## TRANSMITTAL OF DEFENSE NUCLEAR FACILITIES SAFETY BOARD (DNFSB) RECOMMENDATION 2010-2 IMPLEMENTATION PLAN (IP) DELIVERABLE 5.5.3.4

- Waste Feed Delivery Mixing and Sampling Program Plan and Test Requirements, RPP-PLAN-41807, Rev 1A

**Subject:** Review of *Waste Feed Delivery Mixing and Sampling Program Plan and Test Requirements* (ERT-2011-6)

**CONTRACT NUMBER DE-AC27-08RV14800 - ONE SYSTEM - TECHNICAL TEAM  
RESPONSE TO REVIEW OF WASTE FEED DELIVERY MIXING AND SAMPLING  
PROGRAM PLAN AND TEST REQUIREMENTS (ERT-2011-6)**

**Figure 1-1. Mixing and Sampling Program Integrated Schedule**

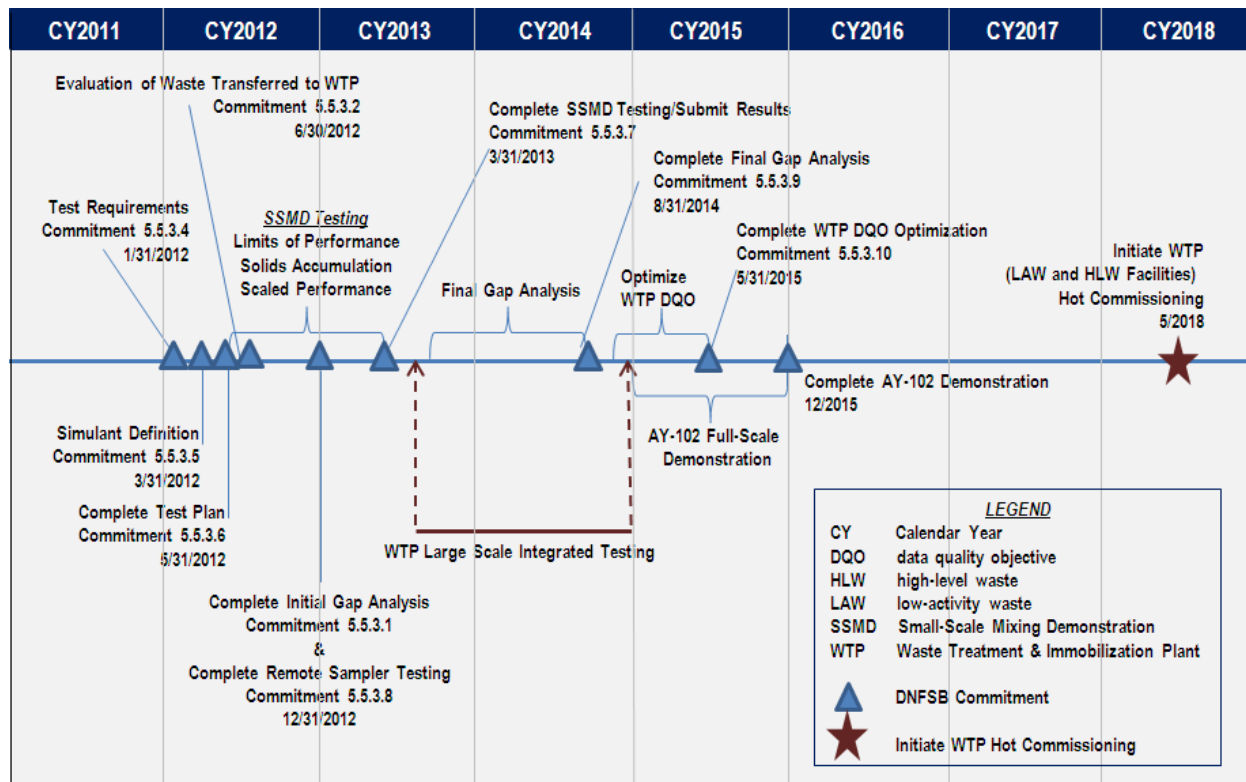
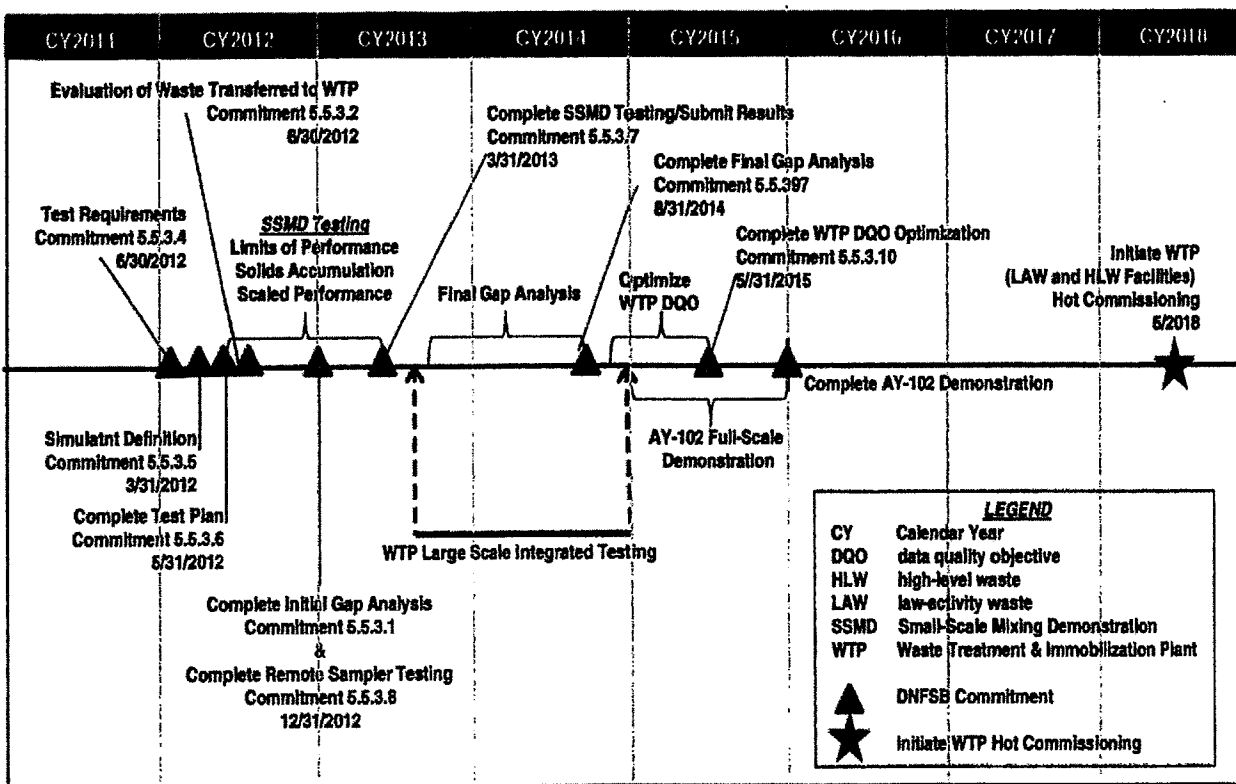
| (7) Change/Release Description: Figure 1-1 was revised to include corrections.  |                                |  |   |

| (8) Change Justification: Figure 1-1 required corrections.  |                                |  |   |
